Service Bulletin

Bulletin No.: 23-NA-074

Subject: Service Engine Soon (SES), Reduced Power, Service Brake, Reduced Steering and/or Stabilitrack Message Illuminated on Driver Information Center (DIC), DTCs P0232, P023F, P0641, P0651, P06A3, P0697, P07BE, P1000, P1009, P2535, P129D, P12A6, P12A8, P2635, P3051, P3052, P3055, P3056, P305B, U0074, U0077, U0121, U0131, U0151, U0415, U0420, U0672, U111A, U18A2, U18C6, U18D2, U2502, U2616 Set

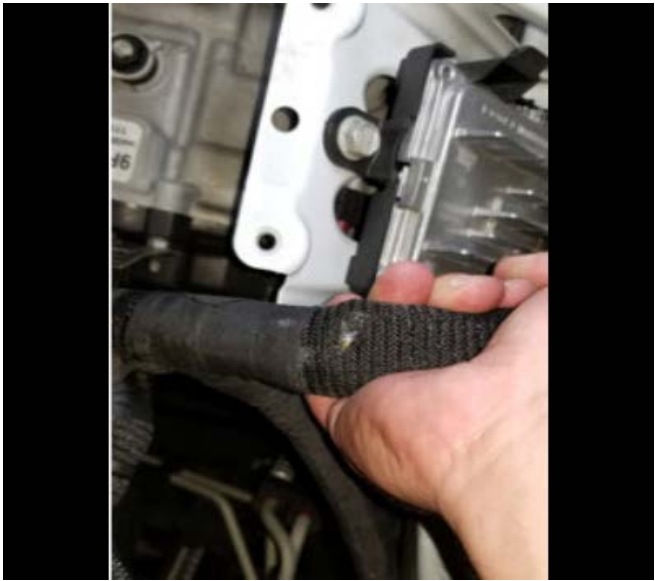
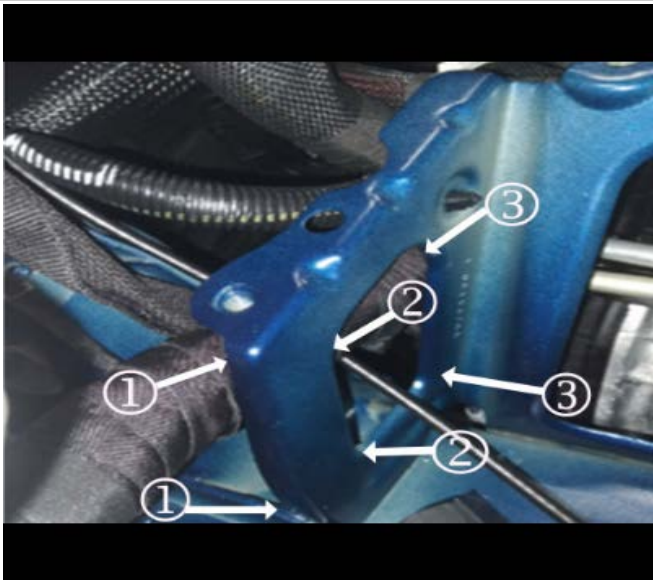
This condition may be caused by wire chafing on the battery tray support bracket.

<p>Correction</p>	<div><p>6326504</p><p>6326606</p><p>Cut 3" long strips of deadener and wrap around the edges on the battery tray bracket, as shown in the picture above.</p></div>
-------------------	---
